World Forum for Harmonization of Vehicle Regulations**Working Party on Lighting and Light-Signalling****Seventy-second session**

Other business – Any other business**Proposal for Supplement 17 to Regulation No. 50 (Position, stop, direction indicator lamps for mopeds and motorcycles)****Submitted by the expert from the International Motorcycle Manufacturers Association ***

The text reproduced below was prepared by the expert from the International Motorcycle Manufacturers Association (IMMA), introducing the possibility of interdependent lamps for dedicated motorcycle lamps. It supersedes ECE/TRANS/WP.29/GRE/2014/7. The proposal reflects the recent amendments to Regulations Nos. 6 and 7, as well as matching the visibility angle requirements of Regulations Nos. 50 and 53. The modifications to the existing text of the Regulation are marked in bold for new or strikethrough for deleted characters.

"1. Front position lamps

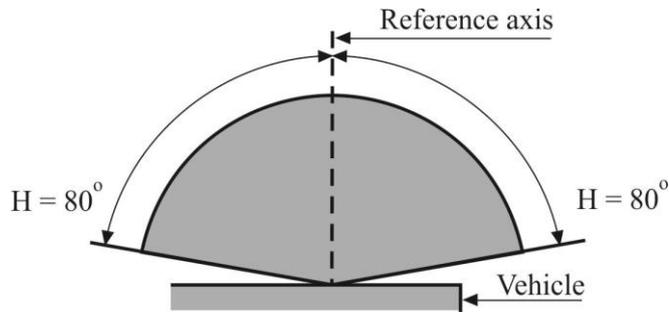
Paragraph 1., amend to read:

$$V = +15^\circ / -10^\circ$$

However, in the case where a device is intended to be installed with its H plane at a mounting height less than 750 mm above the ground, the angle of 10° below the horizontal may be reduced to 5°.

Front position lamps (for a pair of lamps)

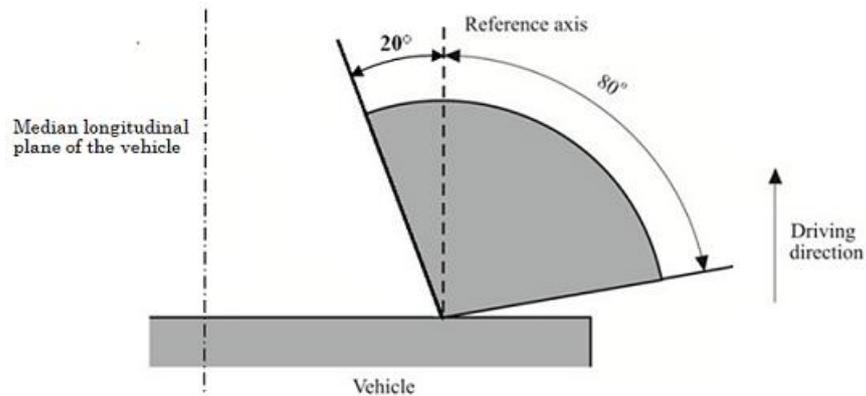
$$V = +15^\circ / -10^\circ$$

However, in the case where a device is intended to be installed with its H plane at a mounting height less than 750 mm above the ground, the angle of 10° below the horizontal may be reduced to 5°.

"2. Rear position lamps

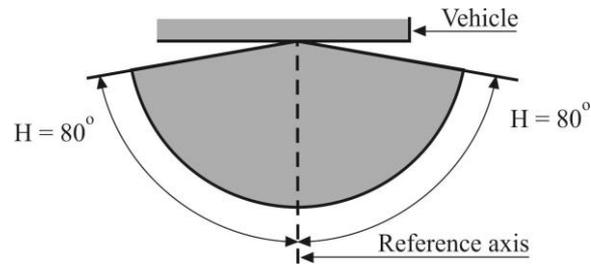
Paragraph 2., amend to read:

$$V = +15^\circ / -10^\circ$$

However, in the case where a device is intended to be installed with its H plane at a mounting height less than 750 mm above the ground, the angle of 10° below the horizontal may be reduced to 5°.

Rear position lamps (for a pair of lamps)

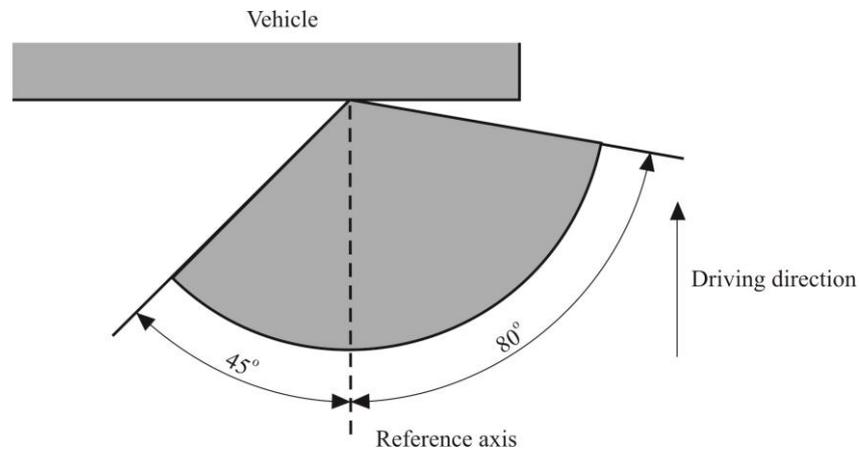
$$V = +15^\circ / -10^\circ$$

However, in the case where a device is intended to be installed with its H plane at a mounting height less than 750 mm above the ground, the angle of 10° below the horizontal may be reduced to 5° .

However, in the case where a device is intended to be installed with its H plane at a mounting height less than 750 mm above the ground, the inward angle of 45° may be reduced to 20° under the H plane."

"3. Direction indicators of categories 11, 11a, 11b, 11c and 12

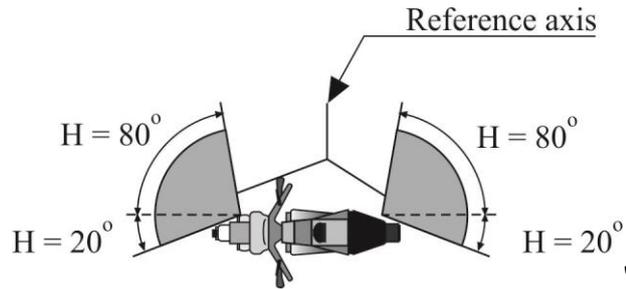
Paragraph 3., amend to read:

$$V = \pm 15^\circ$$

However, in the case where a device is intended to be installed with its H plane at a mounting height less than 750 mm above the ground, the angle of 15° below the horizontal may be reduced to 5° .

Category 11c:

for use at a distance less than 20 mm from the passing beam headlamp.

"4. Stop lamps
 $V = +15^\circ/-10^\circ$

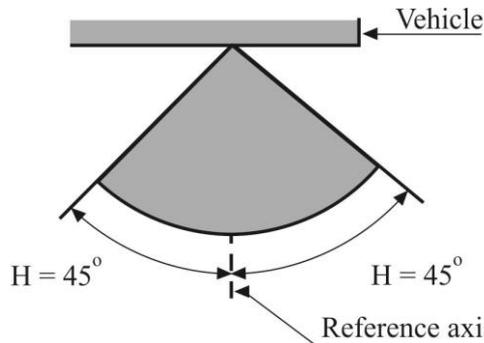
Paragraph 4., amend to read:

However, in the case where a device is intended to be installed with its H plane at a mounting height less than 750 mm above the ground, the angle of 10° below the horizontal may be reduced to 5° .

However, in the case of a pair of lamps, the inboard geometric visibility requirement is deemed to be satisfied if the lamps conform to the photometric values prescribed in the field of light distribution for the approval of the device.
